## 1. PCI Engineering Change Notice – Power Valid to Reset High Timing Specification

<b>TITLE:</b>	Power Valid to Reset High Timing Specification
<b>DATE:</b>	December 6, 1999
<b>AFFECTED DOCUMENT(S):</b>	PCI Local Bus Specification, Revision 2.2, December 18, 1998 and PCI Compliance Checklist, Revision 2.2
<b>SPONSOR:</b>	Jim McManus, Xilinx, Inc.

Figure 4-11: Reset Timing<sup>34</sup>

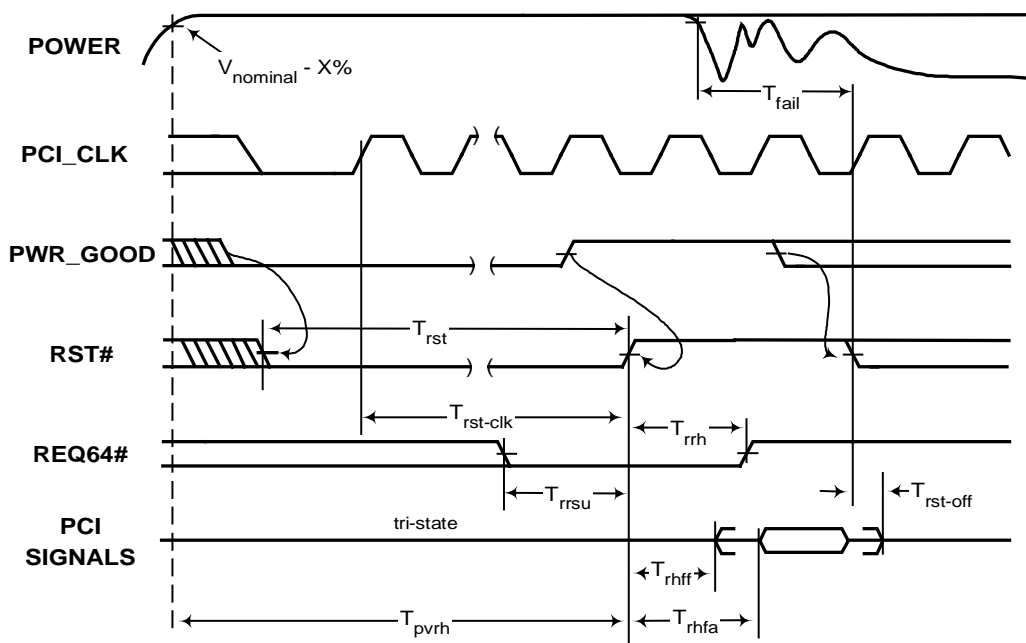
**Chapter 4 “Electrical Specification”, Section 4.3.2 Reset, Figure 4-11, page 135:**

Replace Figure 4-11 with the figure shown below:

The first rising edge of **RST#** after power-on for any device must be no less than  $T_{pvrh}$  after all the power supply voltages are within their specified limits for that device. If **RST#** is asserted while the power supply voltages remain within their specified limits, the minimum pulse width of **RST#** is  $T_{rst}$ .
